PRELIMINARY AND FINAL DRAINAGE PLAN AND REPORT

MOUNTAINS TO VIEW SUBDIVISION

EL PASO COUNTY

MS-18-003

MOUNTAINS TO VIEW SUBDIVISION
FEMA MAP PANEL
1"=500'

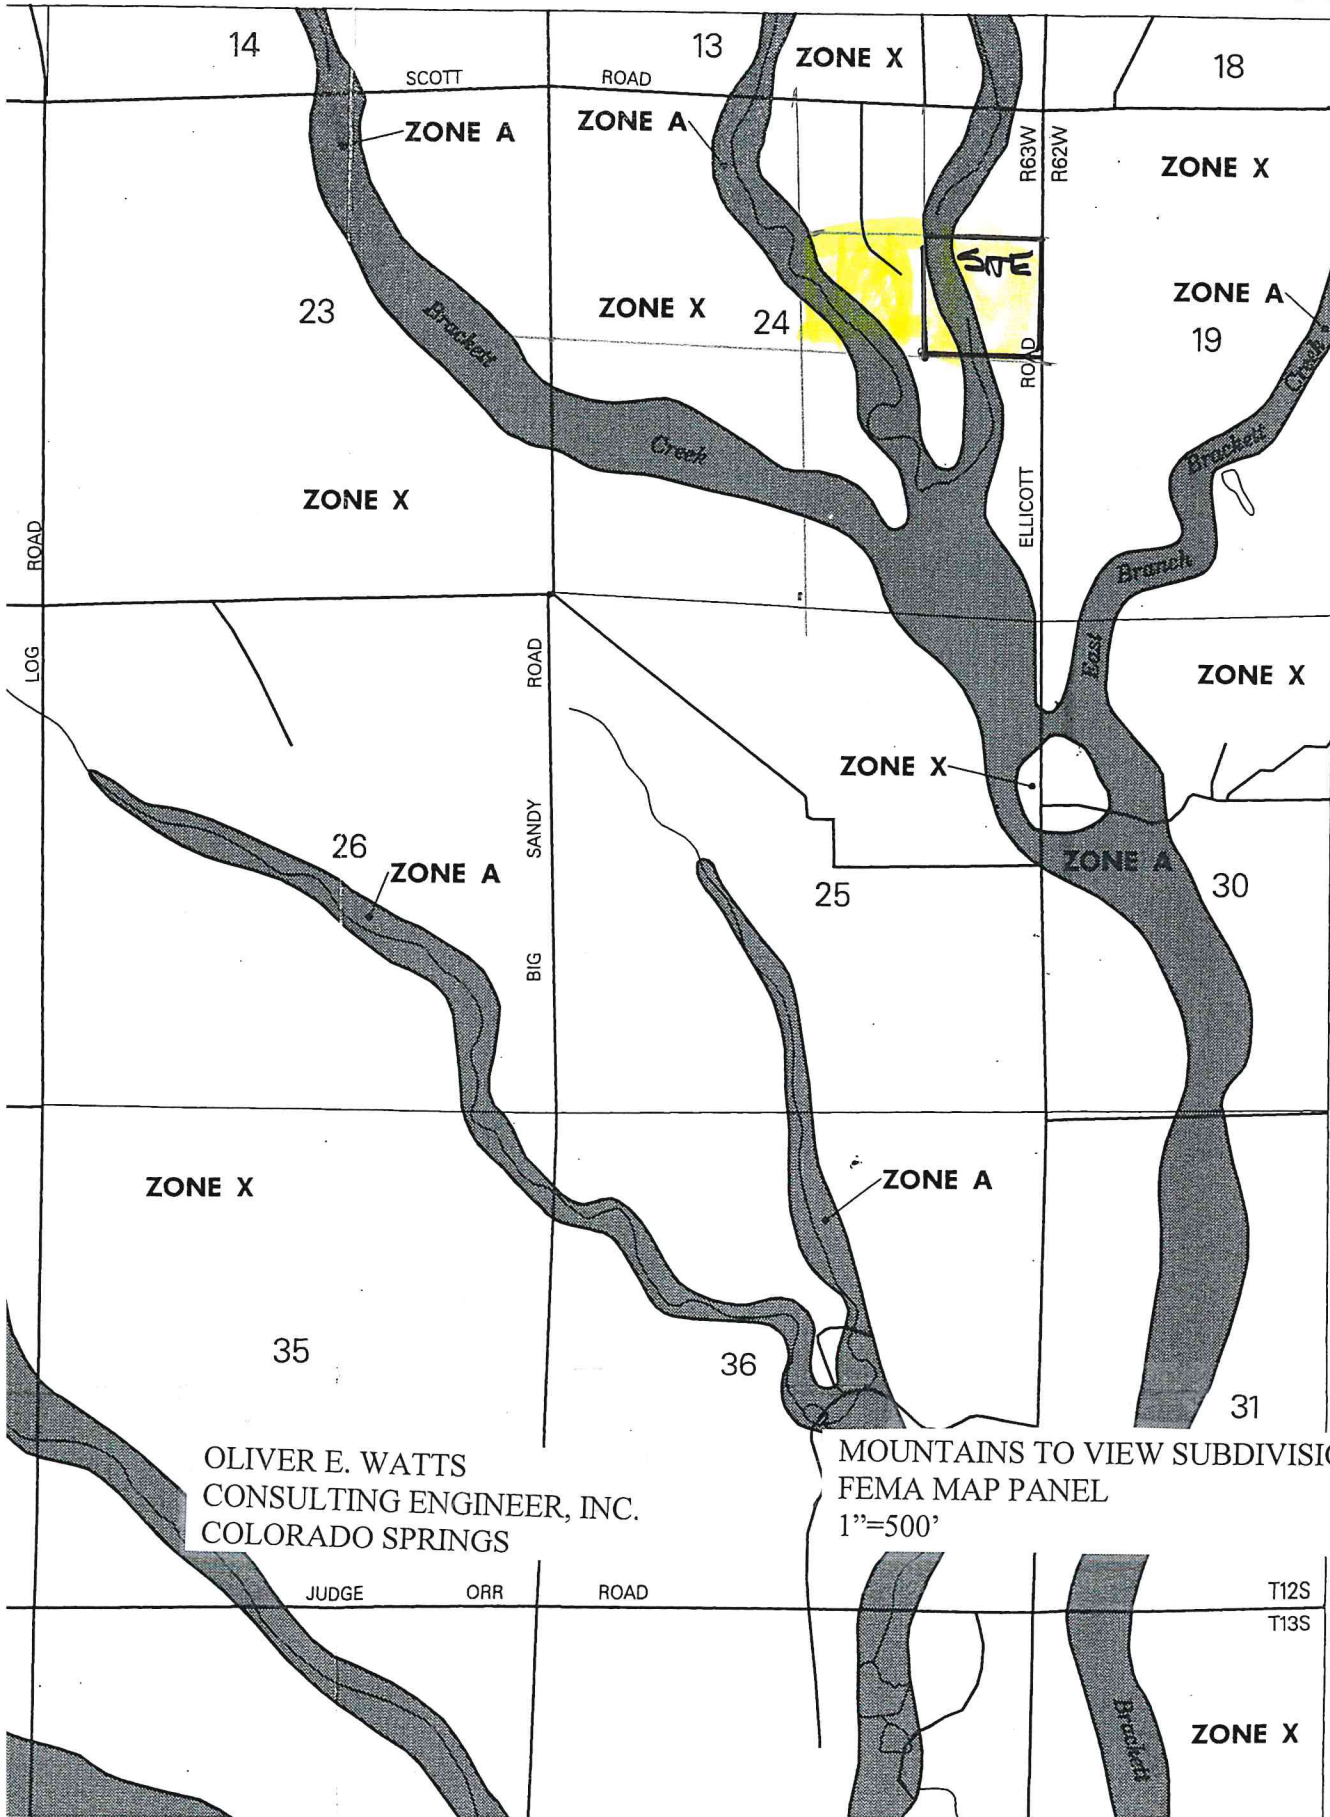
The most updated FEMA map panel number is 08041C0585G, dated 12/7/2018. Please update accordingly.

Provide an updated
map.
